RE: Revised Figure 2 Showing Proposed Borehole and Vapor Probe Locations Former Chevron Service Station 90517 3900 Piedmont Avenue Oakland, California

Former Chevron Service Station 90517, 3900 Piedmont Avenue, Oakland, CA October 31, 2012 Page 2 of 2

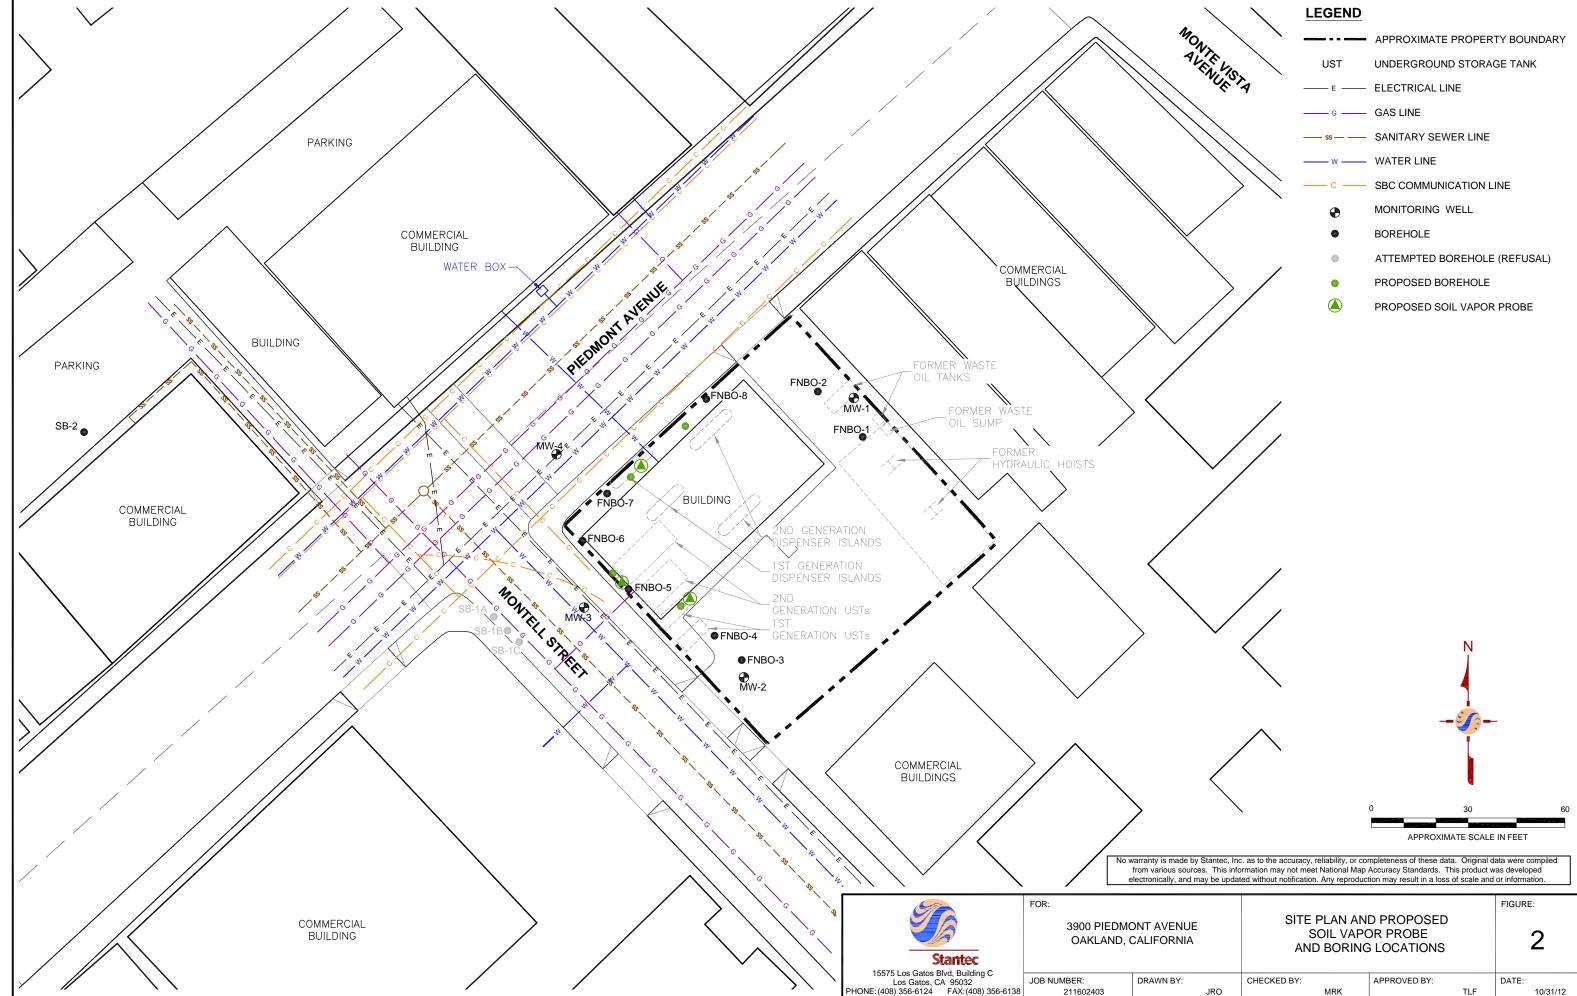
- Stantec proposes to advance four (4) soil boreholes in the planter/walkway areas around the perimeter of the current single-story building to access shallow soil near the former Site features. Reducing from two soil borings to one soil boring on the Montell Street side of the building is justified to avoid utilities and to condense soil boring locations due to their close proximity to each other. Each borehole will be advanced to approximately 10 feet below ground surface (bgs). Representative soil samples will be collected from approximately 2.5 feet bgs, 5 feet bgs, across the current groundwater interface (approximately 7 feet to 9 feet bgs), and at total depth. Soil samples will be analyzed for TPH-GRO by EPA Method 8015, BTEX compounds and MTBE by EPA Method 8260B. Revised Figure 2 shows the proposed borehole locations.

- Stantec proposes to cancel sub-slab probes due to access concerns and proximity to building utilities and instead advance three (3) shallow-soil vapor probes around the building perimeter in the vicinity of the former western-most 1st generation dispenser island and 2nd generation USTs. These shallow soil vapor probes will provide an initial indication of soil vapor concentrations, which can then be used to evaluate whether additional vapor sampling is necessary. Each soil vapor probe will be set at approximately 5 feet bgs. Based on the results of the vapor probe assessment, a subsequent decision on whether to proceed with sub-slab vapor sampling will be evaluated. Revised Figure 2 shows the proposed vapor probe locations.
